Determination 2013/067

Regarding the code-compliance of stone cladding proposed for the recladding of a house in Remuera, Auckland

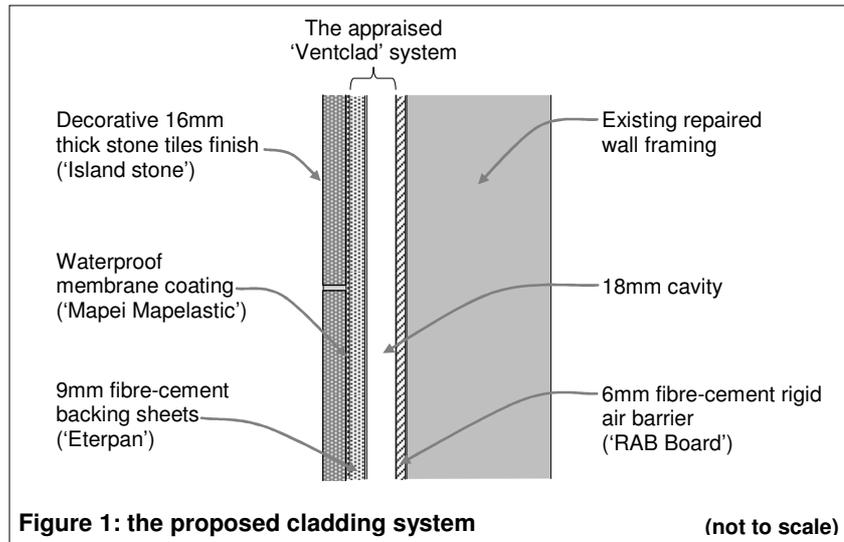
- 2.3.1 The stone cladding system consists of 16mm natural stone tiles fixed to 9mm fibre-cement backing sheets that are coated with a waterproof membrane and fixed through 18mm cavity battens and rigid underlay to the framing as shown in Figure 1.

5.7.2 The expert noted that no control joints are shown in the drawings and considered these would be needed 'at least at corners, possibly over some of the lintels, and likely on the two storey columns.'

- 5.8.1 The expert considered that the information on the proposed stone veneer lacked
- provision for control joints to the tiles
 - a history of satisfactory use of the same or comparable cladding systems, or independent test data/ verification of
 - the stone properties provided by the supplier
 - the strength values provided by the adhesive manufacturer
 - the strength values provided by the membrane manufacturer.
- 5.8.2 Without the above, the expert concluded that 'there was insufficient information to enable a decision on reasonable grounds that the proposed cladding would comply with the New Zealand Building Code.'

- 7.1 In accordance with section 188 of the Building Act 2004, I hereby confirm that the documentation provided does not provide reasonable grounds to be satisfied that the proposed stone veneer cladding, if completed in accordance with the plans and specifications, would comply with Clause B2 Durability insofar as it relates to Clause B1 Structure and Clause E2 External Moisture of the Building Code.
